BULLETIN 25-259

REVISION TRANSMITTAL SHEET

EQUIPMENT/FURNISHINGS - Lavatories - Modify Lavatory Waste Container Assembly and Door Hinge.

EQUIPMENT/FURNISHINGS - Lavatories - Modify Lavatory Waste Container Assembly and Door Hinge.

FORWARD LAVATORY WASTE CONTAINER - MODIFICATION

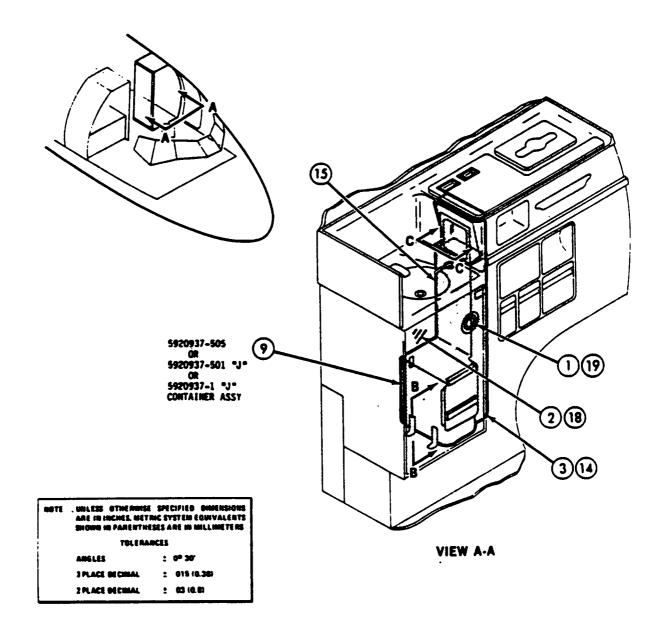
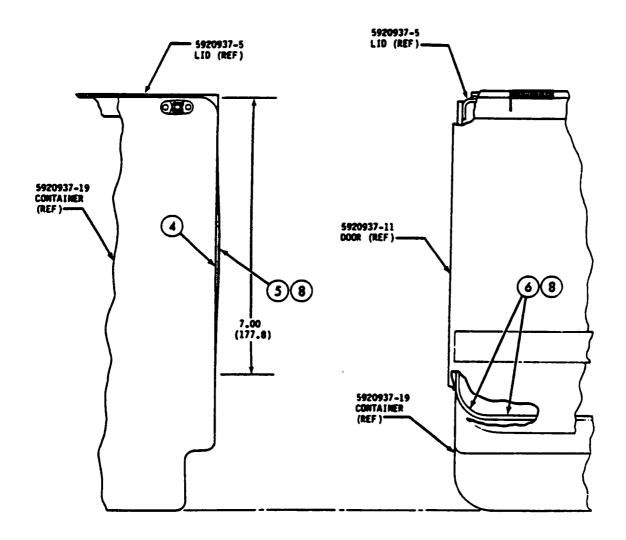
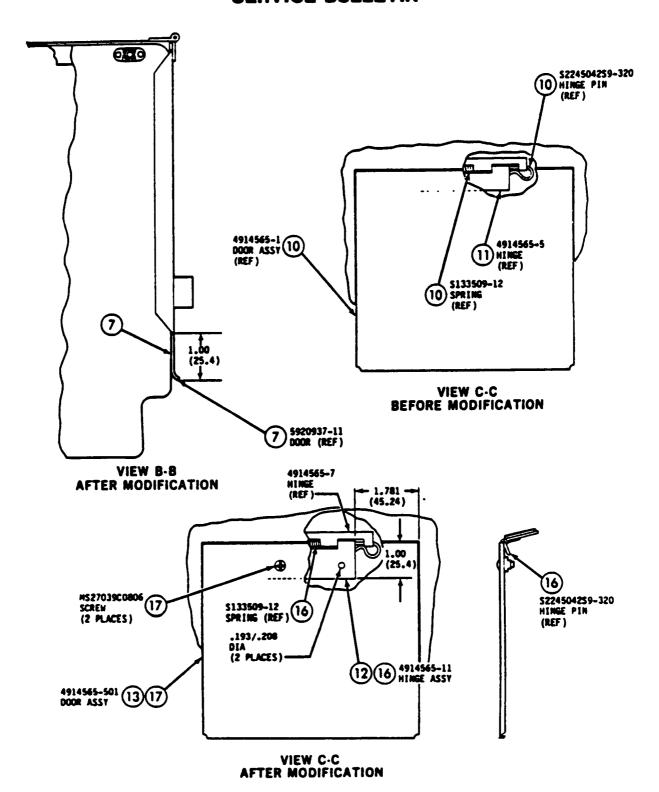
- 1.) LOOSEN CLAMP AND DISCOMMECT FLEXIBLE MOSE FROM CONDITIONED AIR OUTLET ON DOOR ASSEMBLY.
- 2) REMOVE AND RETAIN 5914557-(ANY CONFIGURATION) DOOR ASSEMBLY AND ATTACHING PARTS.
- (3) REMOVE AND RETAIN 5920937-(ANY CONFIGURATION) CONTAINER ASSEMBLY AND ATTACHING PARTS.
- SCRIBE STRAIGHT LINE 7.00 (177.8) INCHES DOWN FROM INTERSECTION BETWEEN 5920937-5 LID AND -19 CONTAINER.
- (5) REMOVE MATERIAL TO SCRIBED LINE.

- 6 REMOVE ANY ROUGHNESS ALONG BOTTOM EDGE OF OPENING IN 5920937-19 CONTAINER AND BLEND INTO VERTICAL STRAIGHT EDGE.
- (7) SEND LOWER 1.00 (25.4) INCH OF 5920937-11 DOOR TO FIT OPENING ALONG BOTTOM OF 5920937-19 CONTAINER. GAP BETWEEN DOOR AND CONTAINER NOT TO EXCEED .030 (.76) INCH.
- 8 APPLY A COAT OF 2-40 FIRE RETARDANT COATING TO INSIDE SURFACES AND REMORKED SURFACES OF CONTAINER ASSEMBLY. IF INSTALLED, MASK OFF FIRE EXTINGUISHER TUBES.
 - (9) REIDENTIFY MODIFIED 5920937-503 CONTAINER ASSEMBLY AS FOLLOWS:

- (10) REMOYE AND RETAIN 5224504259-320 HINGE PIN, 5133509-12 SPRING, AND 4914565-1 DOOR ASSEMBLY.
- T REMOYE 4914565-5 HINGE FROM RETAINED DOOR ASSEMBLY. SCRAPE OFF ANY ADMESTYE FROM DOOR ASSEMBLY.

- POSITION NEW 4914565-11 HINGE ASSEMBLY ON RETAINED DOOR ASSEMBLY AND DRILL TWO .193/.208-INCH DIAMETER HOLES THROUGH DOOR ASSEMBLY USING ATTACHMENT HOLES IN HINGE ASSEMBLY AS GUIDES.

- (13) REIDENTIFY MODIFIED 4914565-1 DOOR ASSEMBLY AS 4914565-501.
- 14) INSTALL MODIFIED 5920937-(AMY CONFIGURATION) CONTAINER ASSEMBLY USING RETAINED ATTACHING PARTS.

- SEAL EXPOSED INTERIOR SURFACES OF CHUTE AND THREE INCHES DOWN THROAT OF CONTAINER ASSEMBLY USING SCOTCH 425 TAPE.
 - (6) INSTALL NEW 4914565-11 HINGE ASSEMBLY, RETAINED S224504239-320 HINGE PIN, AND S133509-12 SPRING ON 4914565-7 HINGE.

AFT LAVATORY WASTE CONTAINER - MODIFICATION

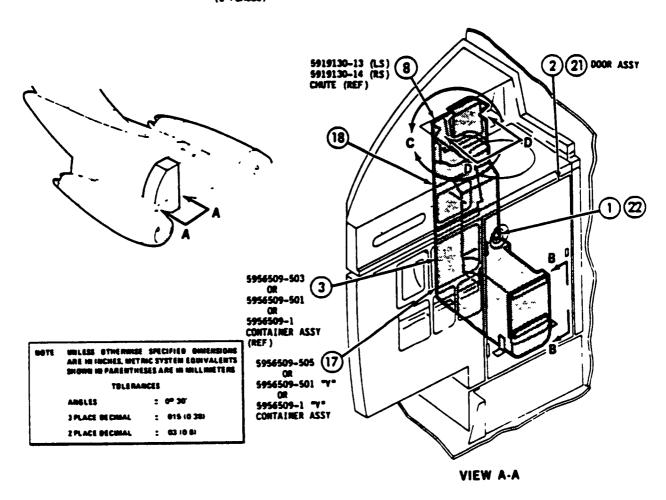
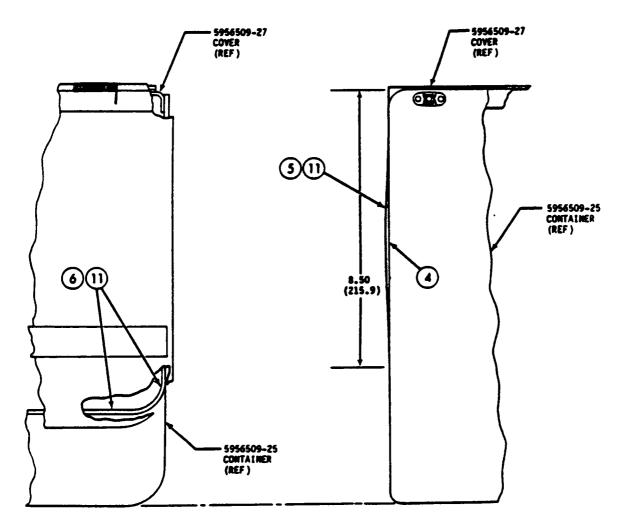
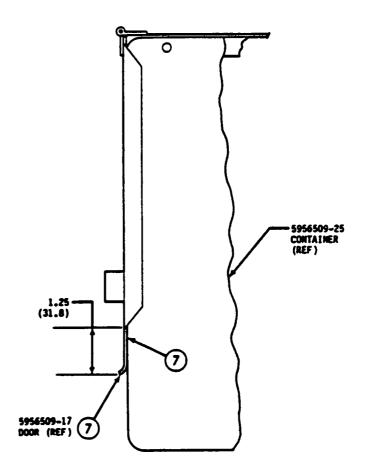
- 1 LOOSEN CLAMP AND DISCONNECT FLEXIBLE HOSE FROM CONDITIONED AIR OUTLET ON DOOR ASSEMBLY.
- 2) REMOVE AND RETAIN 5914557-(ANY CONFIGURATION) DOOR ASSEMBLY AND ATTACHING PARTS.
- (3) REMOVE AND RETAIN 5956509-(ANY CONFIGURATION) CONTAINER ASSEMBLY AND ATTACHING PARTS.
- SCRIBE STRAIGHT LINE 8.50 (215.9) INCHES DOWN FROM INTERSECTION BETWEEN 5956509-27 COVER AND -25 CONTAINER.
- (5) REMOVE MATERIAL TO SCRIBED LINE.

- 6 REMOVE ANY ROUGHNESS ALONG BOTTOM EDGE OF OPENING IN 5956509-25 CONTAINER AND BLEND INTO VERTICAL STRAIGHT EDGE.
- BEND LOWER 1.25 (31.8) INCH OF 5956509-17 DOOR TO FIT OPENING ALONG SOTTOM OF 5956509-25 CONTAINER. GAP BETWEEN DOOR AND CONTAINER NOT TO EXCEED .030 (.76) INCH.
- REMOVE 5919130-13 LEFT SIDE (-14 RIGHT SIDE) CHUTE. RETAIN ATTACHING PARTS. RETAIN CHUTE IF OPERATOR ELECTS TO MODIFY CHUTE.
- 9) INSTALL NEW 5919130-21 LEFT SIDE (-22 RIGHT SIDE) CHUTE USING RETAINED ATTACHING PARTS.

- FABRICATE AND INSTALL 5919130-8F3 LEFT SIDE (-8F4 RIGHT SIDE) EXTENSION USING 15 MS20470AD3-3 RIVETS. REIDENTIFY MODIFIED CHUTE AS 5919130-21 LEFT SIDE (-22 RIGHT SIDE).
- APPLY A COAT OF Z-40 FIRE RETARDANT COATING TO INTERIOR SURFACES AND REMORKED SURFACES OF CONTAINER ASSEMBLY AND INTERIOR AND EXTERIOR SURFACES OF CHUTE. IF INSTALLED, MASK OFF FIRE EXTINGUISHER TUBES.
 - (12) REIDENTIFY MODIFIED 5956509-503 CONTAINER ASSEMBLY AS FOLLOMS:

- (13) REMOYE AND RETAIN \$224504259-320 HINGE PIN, \$133509-12 SPRING, AND 4914565-1 DOOR ASSEMBLY.
- REMOVE 4914565-5 HINGE HALF FROM RETAINED DOOR ASSEMBLY. SCRAPE OFF ANY ADMESTVE FROM DOOR ASSEMBLY.
- POSITION NEW 4914565-11 HINGE ASSEMBLY ON RETAINED DOOR ASSEMBLY AND DRILL TWO .193/.208-INCH DIAMETER HOLES THROUGH DOOR ASSEMBLY USING ATTACHMENT HOLES IN HINGE ASSEMBLY AS GUIDES.
- (16) REIDENTIFY MODIFIED 4914565-1 DOOR ASSEMBLY AS 4914565-501.
- 17) INSTALL MODIFIED 5920937-(ANY CONFIGURATION) CONTAINER ASSEMBLY USING RETAINED ATTACHING PARTS.

- SEAL EXPOSED INTERIOR SURFACES OF CHUTE AND THREE INCHES DOWN THROAT OF CONTAINER ASSEMBLY USING SCOTCH 425 TAPE.
 - 19 INSTALL NEW 4914565-11 HINGE ASSEMBLY, RETAINED 5224504259-320 HINGE PIN, AND \$133509-12 SPRING ON 4914565-7 HINGE.
 - (20) INSTALL MODIFIED 4914565-501 DOOR ASSEMBLY USING TWO MS27039C0806 SCREWS.
 - (21) INSTALL RETAINED 5914557-(ANY CONFIGURATION) DOOR ASSEMBLY AND ATTACHING PARTS.
 - (22) CONNECT FLEXIBLE HOSE TO CONDITIONED AIR OUTLET.

DETAIL OF 5919130-8F3 (LS)
5919130-8F4 (RS)
FABRICATE CHUTE FROM 6061-T6 ALUMINUM
CLAD SHEET, .020 X 2 X 21 INCHES, MATERIAL
SPECIFICATION QQ-A-250/11, TEMPER 6

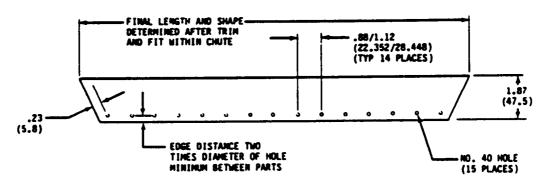
DETAIL OF 5919130-8F3 (LS)
5919130-8F4 (RS)
FABRICATE CHUTE FROM 6061-T6 ALUMINUM
CLAD SHEET, .020 X 2 X 21 INCHES, MATERIAL
SPECIFICATION QQ-A-250/11, TEMPER 6.

VIEW D-D BEFORE MODIFICATION

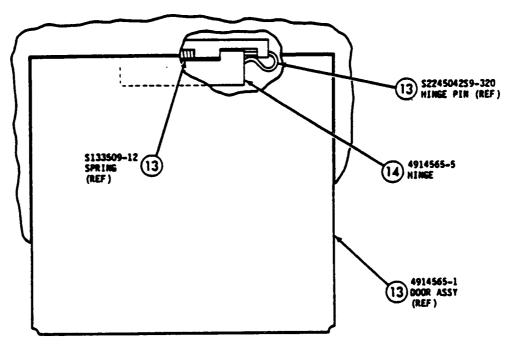
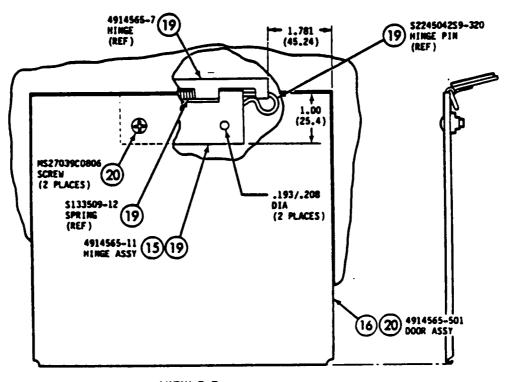
Page 22: Changed dimension in View C.
